ADDENDUM #1 – MARCH 19, 2024

RE: NORTH BEND SCHOOL DISTRICT
North Bay School Kitchen Remodel
Project #23.87

FROM: HGE ARCHITECTS, Inc.
333 South 4th Street
Coos Bay, Oregon 97420
541-269-1166

SHEET TITLE:
BUILDING SECTIONS

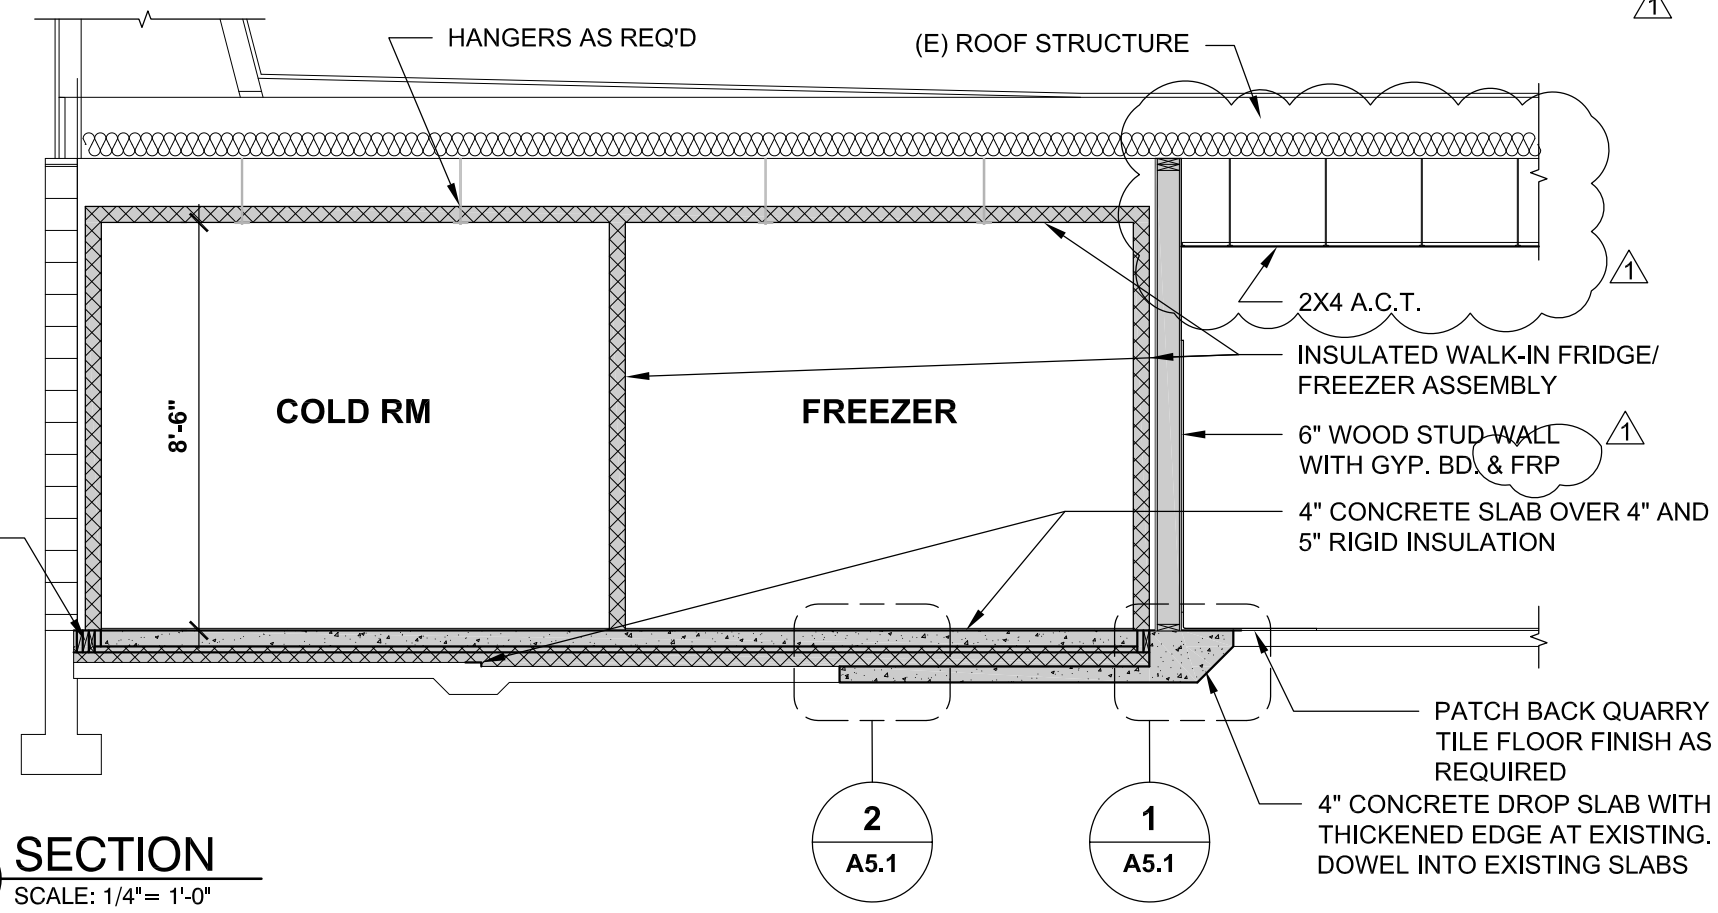
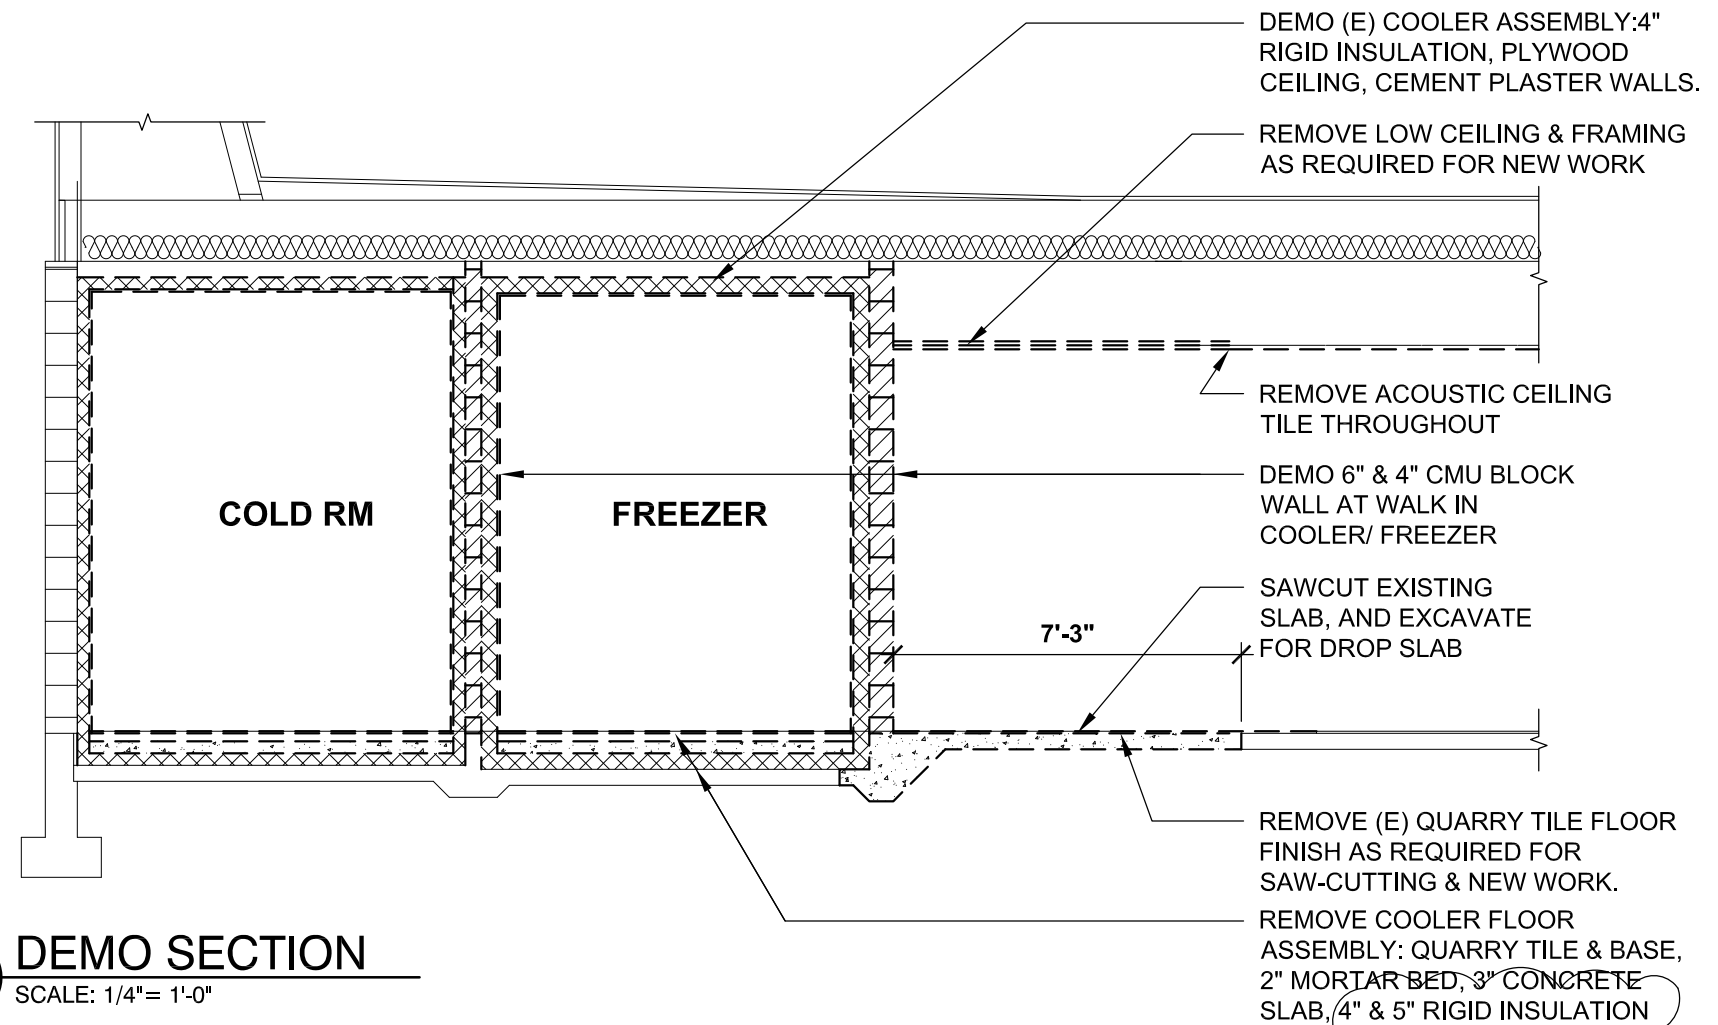
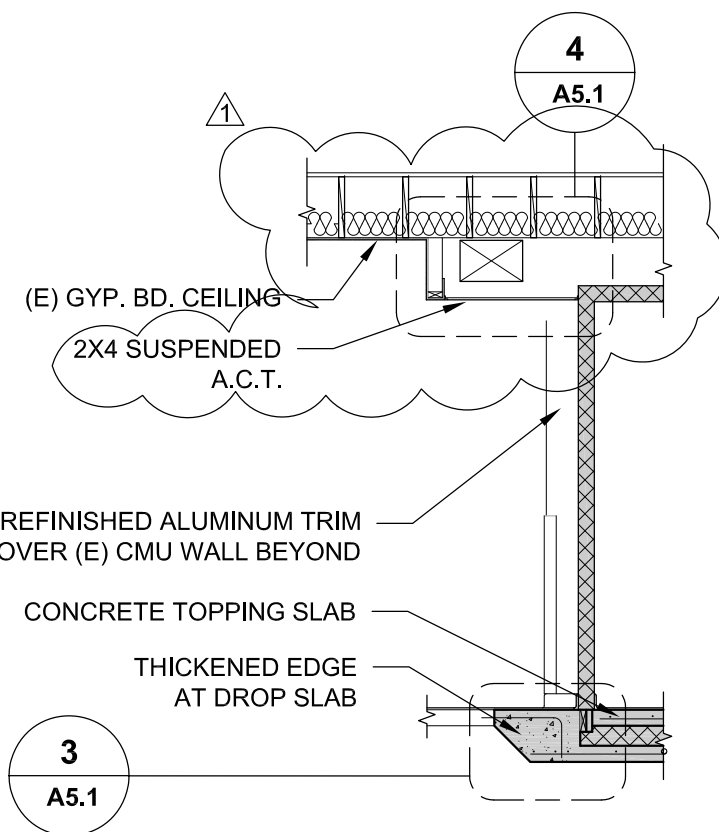
4. Sheet A3.1 Building Sections: REPLACE Sheet A3.1 with REVISED Sheet A3.1 attached.

- i. Drawing 1, Section:
 - 1. Revise ceiling construction to reflect change from glue-on A.C.T. to suspended A.C.T. with 2x4 bulkhead.
 - 2. Note regarding wood stud wall: REVISE as follows: "2X6 WOOD STUD WALL WITH GYP. BD. & FRP".
- ii. Drawing 2, Demo Section:
 - 1. Note regarding removal of cooler floor assembly: ADD to end of Note the following: "SLAB, 4" & 5" RIGID INSULATION".
- iii. Drawing 3, Section at Cooler Front:
 - 1. Revise ceiling construction to reflect change from glue-on A.C.T. to suspended A.C.T. with 2x4 bulkhead.
 - 2. DELETE Note: "BRACE (E) SOFFIT WITH 2X FRAMING".

4 BULKHEAD
 A5.1 SCALE: 1-1/2" = 1'-0"

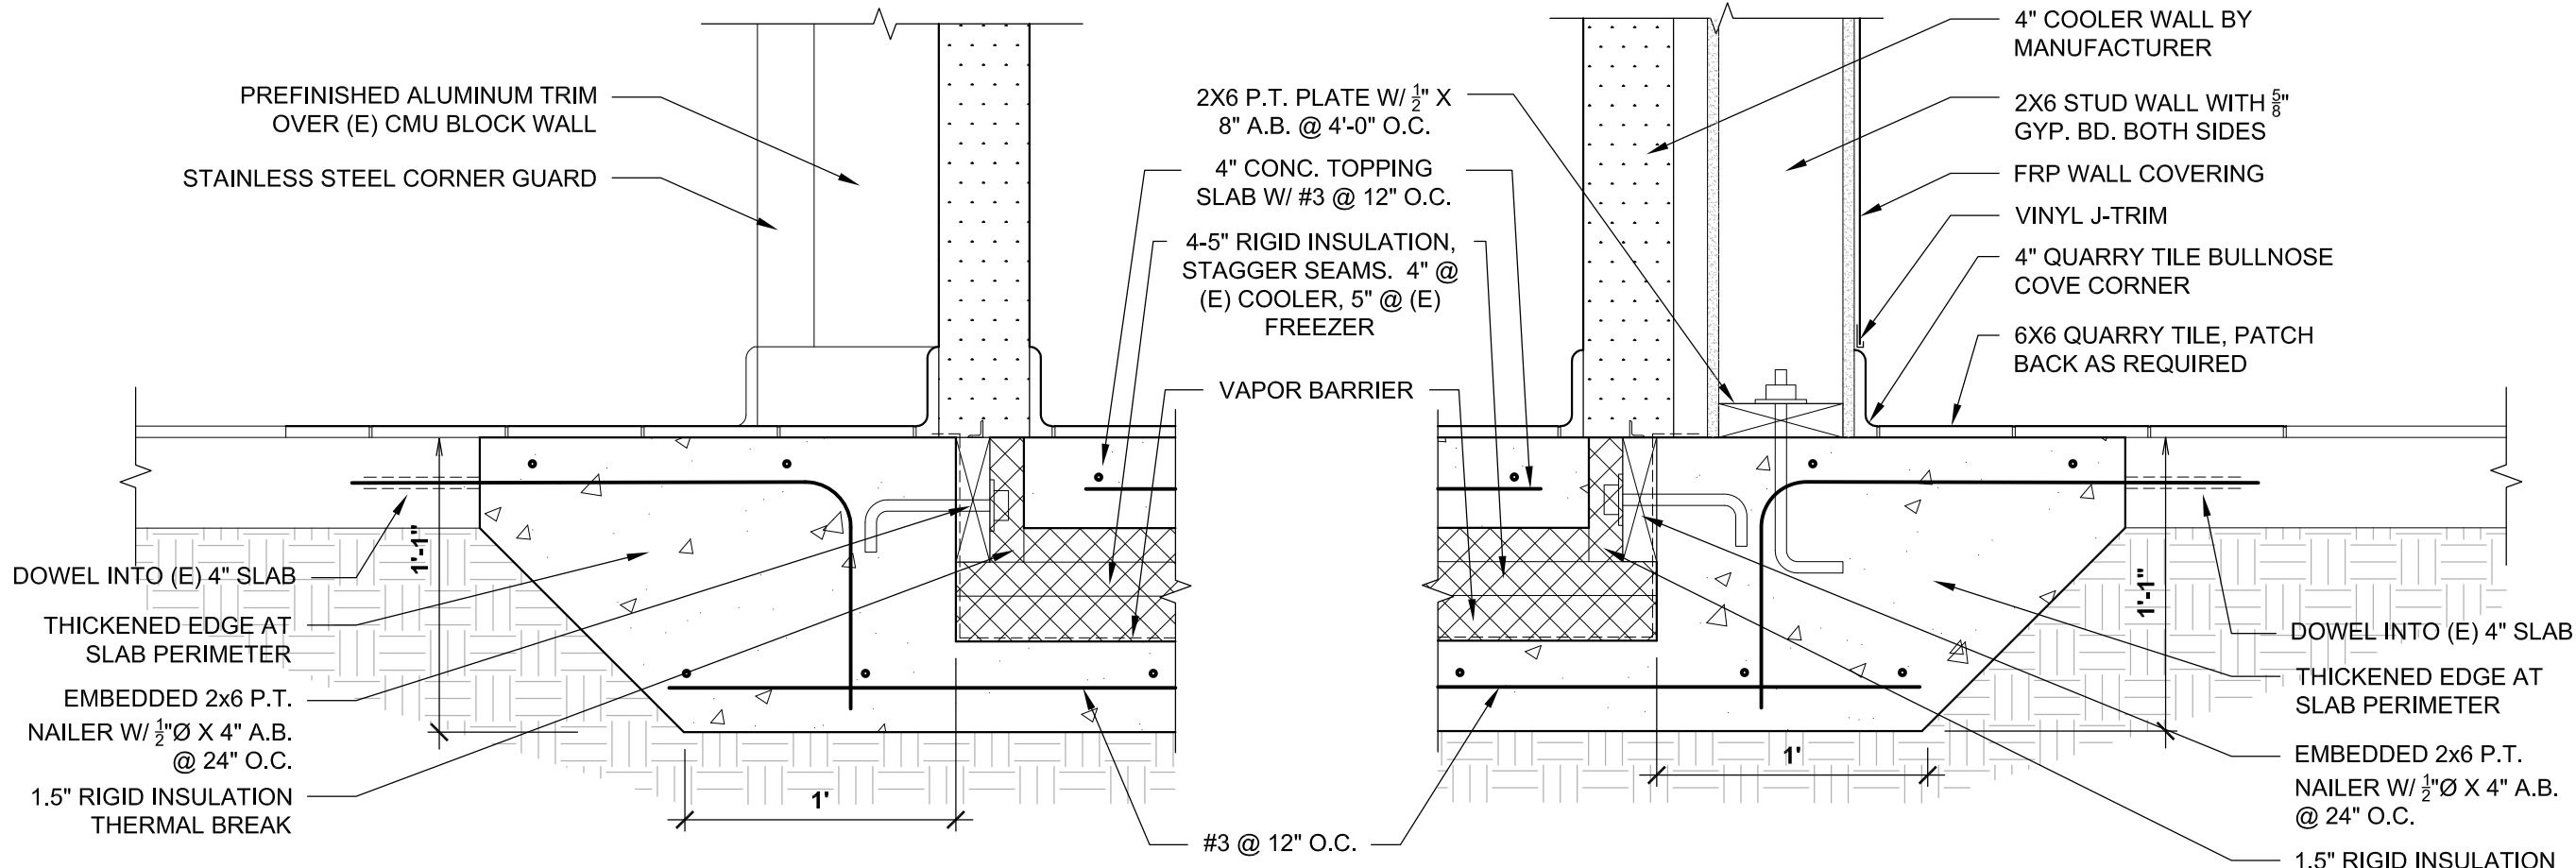
- 5. Sheet A5.1 Details:** REPLACE Sheet A5.1 with REVISED Sheet A5.1 attached.
- a. Revision Summary:
 - i. Drawing 4, Bulkhead:
 1. REVISE ceiling construction to reflect change from glue-on A.C.T. to suspended A.C.T. with 2x4 bulkhead.
 2. ADD Note: "GRILLE BEYOND, TIE INTO (E) DUCTING".
 3. ADD Note: "2X4 BULKHEAD W/ 5/8" GYP. BD."
 4. DELETE Note: "(E) SOFFIT FRAMING".
 5. DELETE Note: "BRACE (E) SOFFIT WITH 2X FRAMING".
 6. DELETE Note: "PREFINISHED METAL TRIM W/ HEMMED EDGES".
- 6. Sheet A5.2 Details and Interior Elevation:** REPLACE Sheet A5.2 with REVISED Sheet A5.2 attached.
- a. Revision Summary:
 - i. Drawing 3, Interior Elevation – South:
 1. REVISE bulkhead to reflect changes to ceiling construction.
 2. ADD Note: "GRILLES AT (E) LOCATIONS".
 3. REVISE cooler wall to reflect dimensional changes, add electrical outlet.
